FIELD OBSERVATION REPORT

East Hardin Middle School, Hardin County Schools, Elizabethtown, KY 201752.01 -CA8

Report No: 19

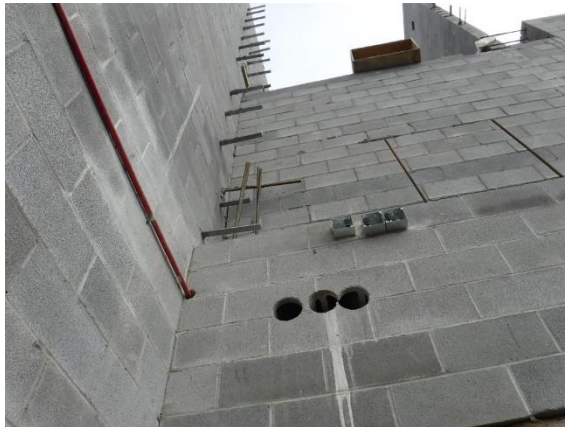
- b) Ground faced concrete block walls are being laid for the main east-west corridor on the first floor in Areas A and B.

- c) The ground faced block needs to be cleaned and sealed. Overall the work is acceptable thus far. Block the block joints and the false joints have been filled with mortar and tooled with a concave joint. The joints at Lincoln Trail Elementary School are struck for the block joints and the false joints are left open.

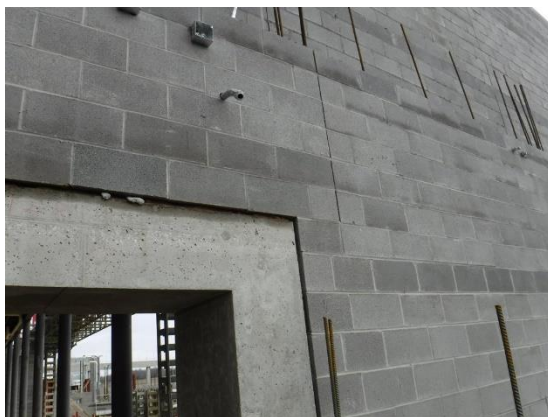
- e) The concrete block fire wall around the Gym and extending in front of the Cafeteria consists of two independent block walls. The wall ties sticking out of the Gym wall would tie these two walls together so they do not act independently. The ties will be removed and two courses of block will be cut free from the Gym wall.

- f) Concrete block wall over the concrete portals at the fire wall, do not bear on the portals. The control joint at the end of the bond beam must be on the wall side of the portal.

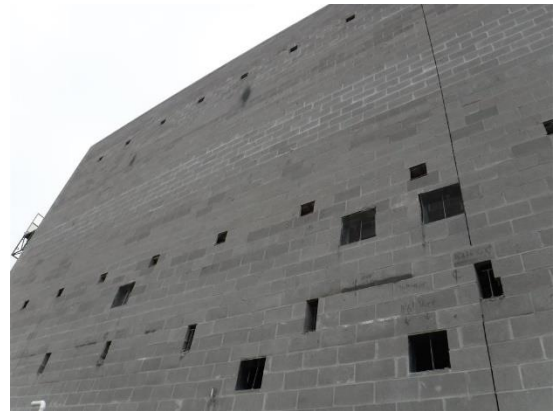
- i) Masons were reworking the exterior walls at the east side of Area B where the window openings were laid as if the windows would be two stories high. The block at the jambs has been cut back to reveal the grouted cells. JRA, Solid Ground and Icon have noted this discrepancy in their reports. The corrective measures cited was to remove the upper portion of the block and reinforcing to restore the wall to the original design intent.

- j) Doyle and I observed the mason removing faces of every other course of the jamb block 8" from the jamb. This meant that the face on one side of the window opening was left in place at the bond beam. Doyle told the mason that the bond beams at the heads of the first floor windows must be installed with full 8" bearing on both sides including replacing the full face of the block to form a bond beam. Either the block and the grout at the bond beam must be removed so the beam can be fully installed or the mason can drill the grout the full 8" from the jamb and anchor the reinforcing with structural epoxy into the grout. Solid Ground needs to verify that the work is properly done in their SPIN reports. The outer webs of the block above the bond beam will be cut to form a "U" shape to fit around the grout. If this work cannot be done to provide full bearing and an acceptable appearance in the room side of the wall, the entire wall needs to be removed and relaid. The grout above the jambs needs to be bonded to the infill block cores.
